**MOORPARK CITY COUNCIL  
AGENDA REPORT**

**SUBJECT: Consider Additional Funding for Additional Work to Perform Installation of Revised Exterior Trellis Materials and Amendment No. 5 to the Agreement with Standard Drywall, Inc. for the Ruben Castro Human Services Center**

**Project ; Ruben Castro Human Services Center, City of Moorpark**

**Re; Exterior Trellis/Sunshade feature at Building B**

**ATTACHMENT 2**

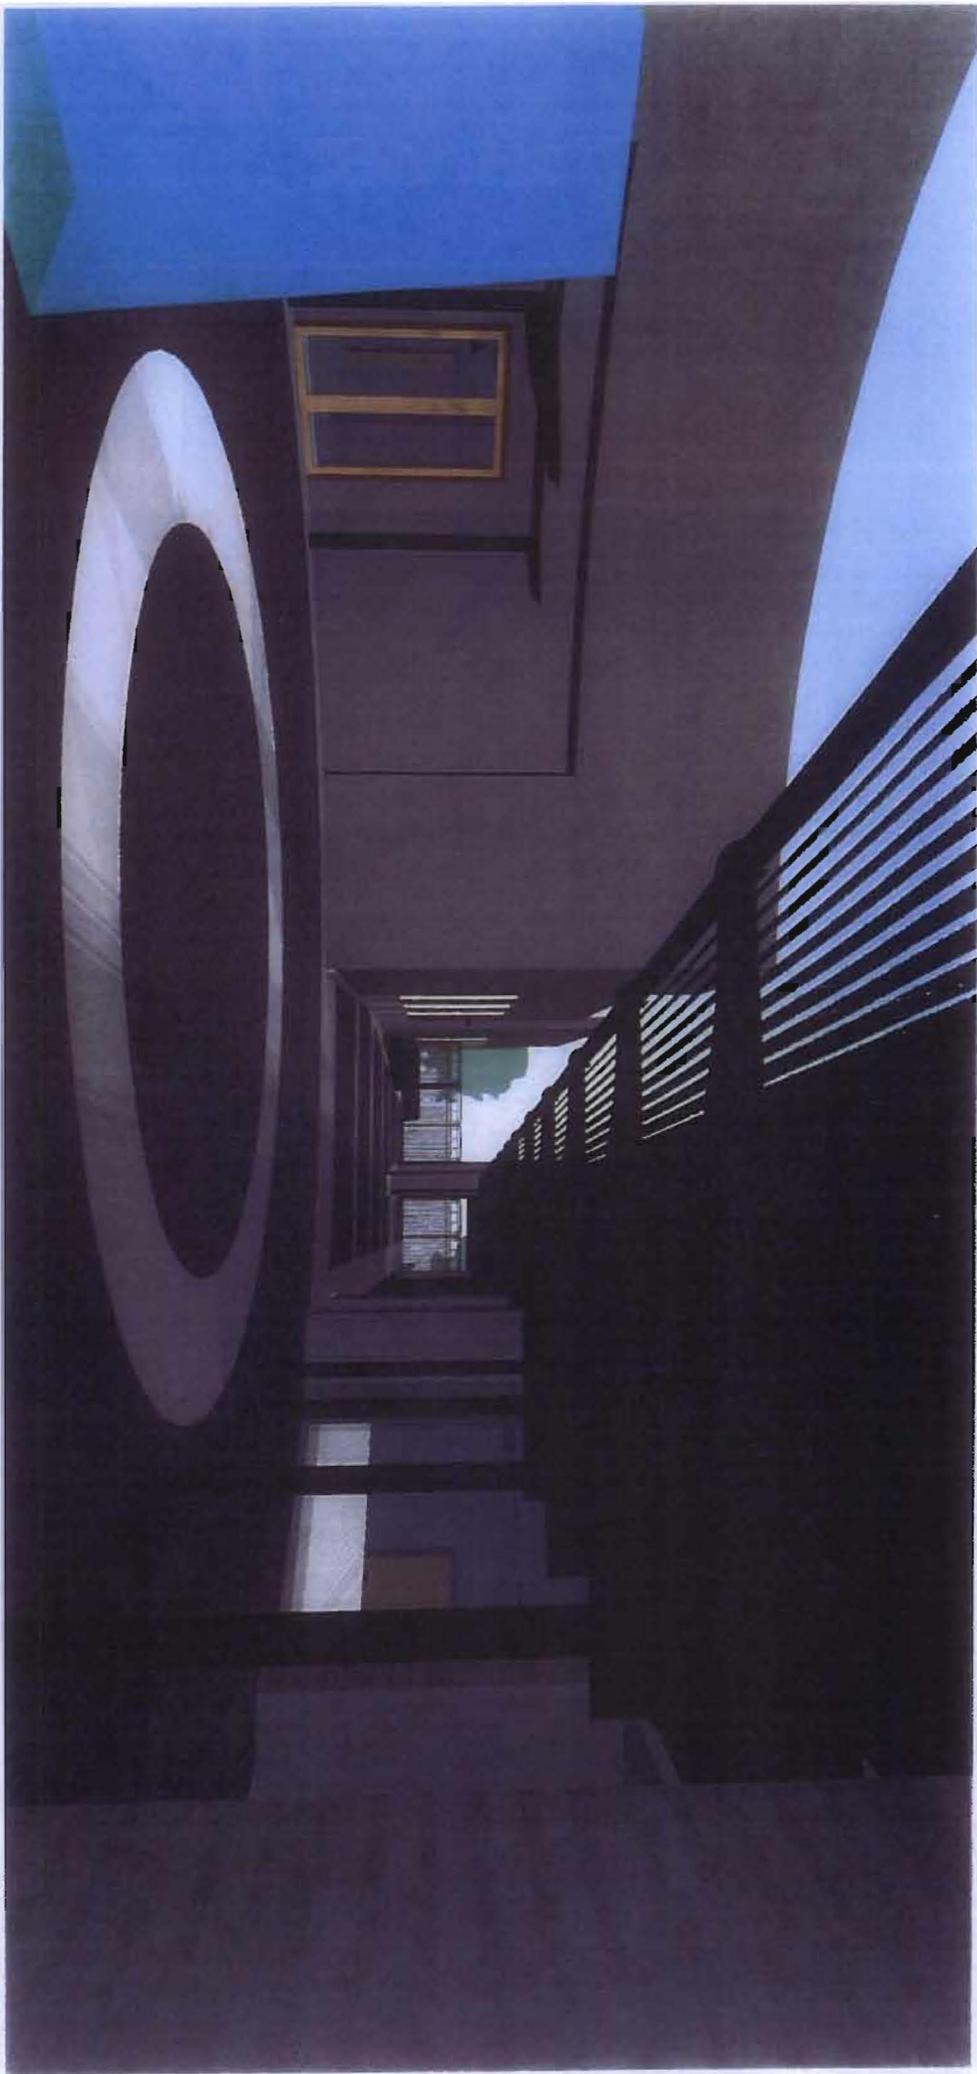
The Trex material is primarily used in deck construction. The manufacturer would not warrant the use of the Trex material to span beyond 16 to 24 inches without additional lateral support, as it would most likely sag over time. (See Attachment 2- Photograph of the Trex originally installed)

About the second week of August, 2012, installation of the Trex material at the East façade and the South façade starting from the East working to the West was started. Immediately following installation of several sections of the system, it became apparent that the nature of the Trex material would not maintain a straight line along the material length. The material, although fastened to the structural support system per the plan details, developed for lack of better terms, a wavy appearance along with a horizontal sag between the outrigger supports. Along the length of the Trex members, spacing varied significantly and a sag of +1/2" between the outriggers was evident. Concerned with the appearance of the installation, we suspended further installation pending further review by the HMC Architects.

On August 20, 2012, following confirmation by BBC that all specified and detailed directions were followed during installation of the Trex material, RFI #0326 was submitted to HMC Architects for their review and response. Included in the RFI were comments received from the material manufacture stating the specified material was not designed to span more than 16"-20" between supports. As mentioned above, the structural steel support system is spaced equally between 10 feet and 15 feet. Response to the RFI was received August 22, 2012 indicating options to install additional spacers at a 24" interval and/or suggest pricing for replacement of the specified materials with similar shaped aluminum members, fiberglass members or perforated flat sheet metal material. Installation of the additional spacers was performed to confirm if the suggestion resolved the uneven spacing of the Trex members. Although the spacing was improved, the fix did not fully eliminate the uneven spacing (photo # 1) nor the material sag between support members (photo # 2).

ATTACHMENT 3

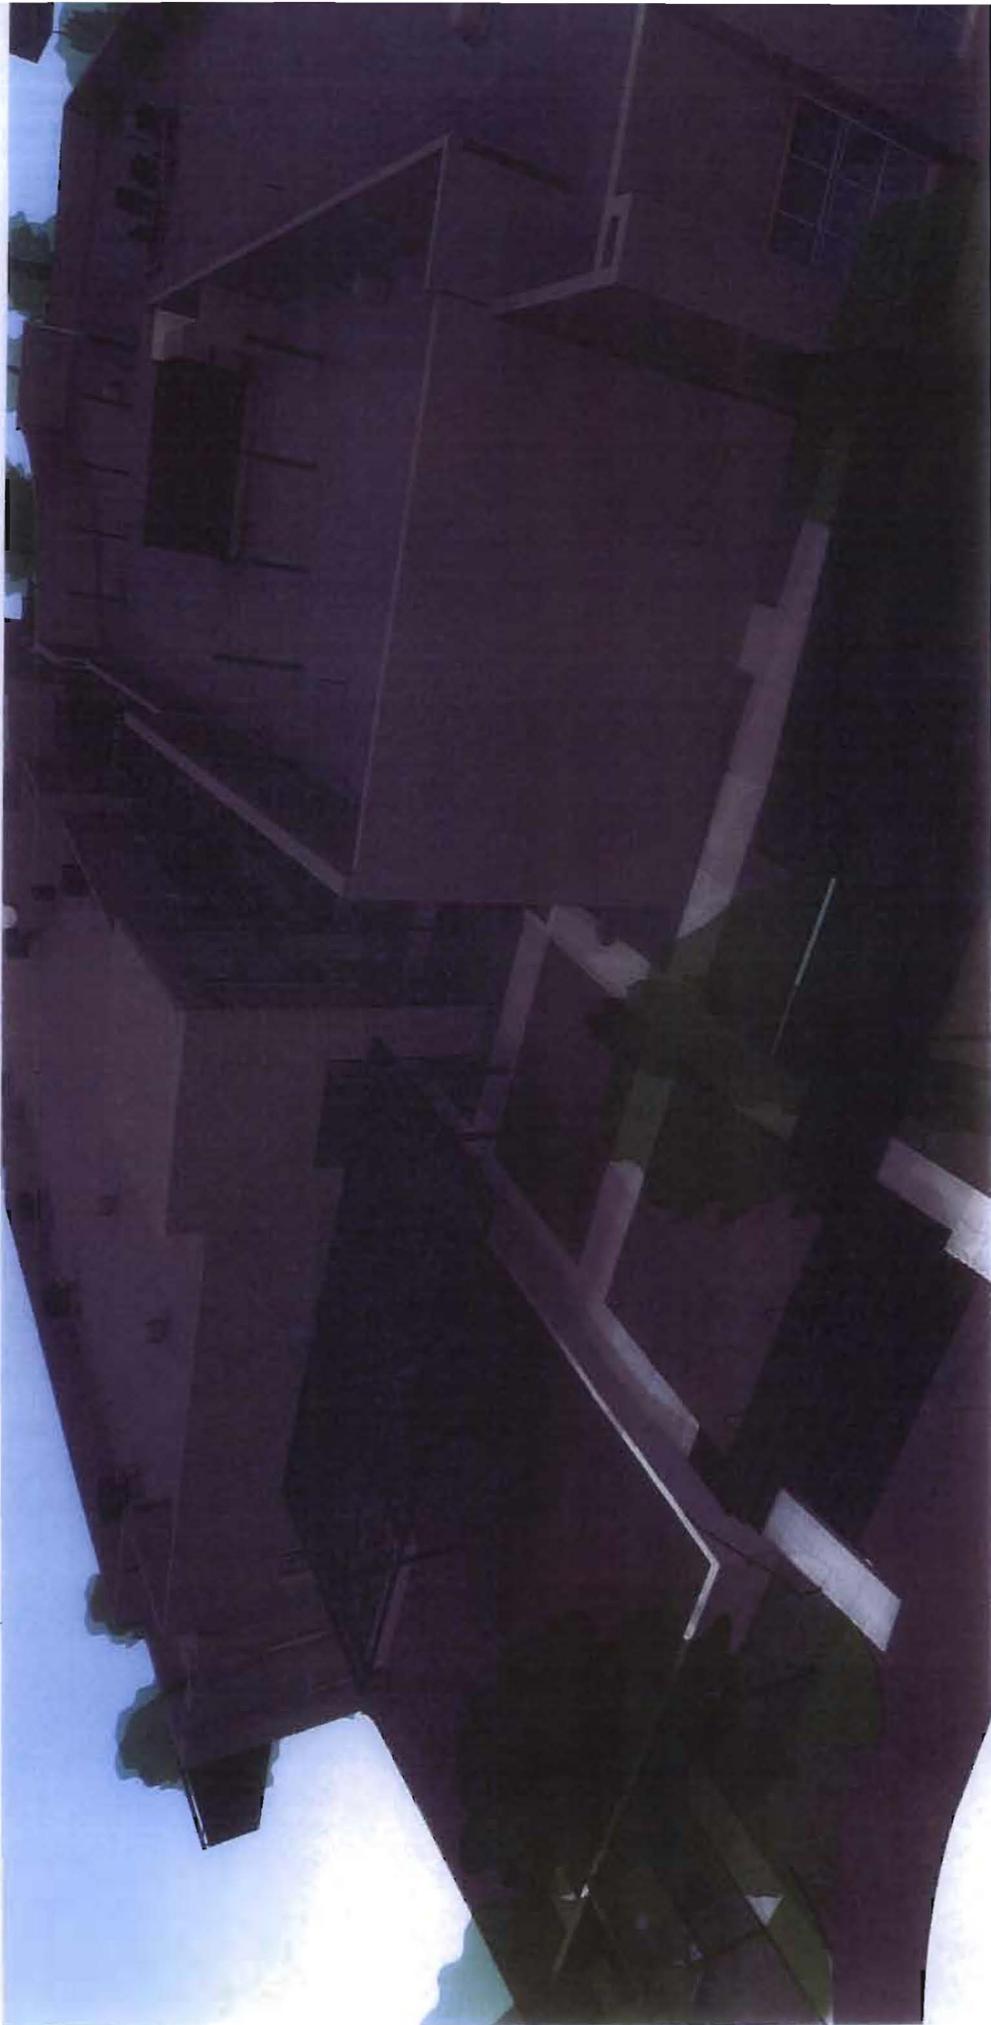
Balfour-Beatty, together with City staff, sought alternative materials, including different sizes and thicknesses of tube steel, angle iron, and "C" channel to replace the original Trex composite lumber. While material and pricing costs were being collected, Balfour-Beatty also researched a manufacturer called Airolite, which produces a number of sunshade products including louvers, grilles, and other sun control applications. A rendering of the staff-recommended alternative is Attachment 3.

After further discussion and research by the City and BBC, a secondary option is being considered. At Building A (VCMC), prefabricated aluminum eyebrow sunshades have been installed. Using this same concept, the supplier of the sunshades has developed a proposal to provide pre-fabricated sunshade sections that are pre-finished and engineered to span the existing structural steel support system. Installation pricing is in progress and will be shared with the City immediately upon receipt. At that time discussion will take place considering all options including effectiveness and cost impact of each option. The intent of these discussions will allow for a final selection of the most cost effective and lowest maintenance solution. Included in the decision will be credit back to the City for the unused cost for installation of the originally specified Trex materials. The Trex material itself is not returnable and will be handed over to the City for its discretionary use.

Based on factors including the original design appearance intent, ability to attach to the existing outriggers, labor cost for installation, and future maintenance costs, City representatives and Balfour-Beatty concurred that the Airolite sunshade product would be the overall superior choice of the various alternatives available to replace the Trex composite material. An additional consideration is that the Airolite closely resembles the shade features used above south and west facing windows in Building A. The total cost for the material and installation of the Airolite sunshades is \$160,772.

Contractor's Scope of Services is amended to include the labor and materials required to provide pre-fabricated sunshade sections that are pre-finished and engineered to span the existing structural steel support system at the Ruben Castro Human Services Center.
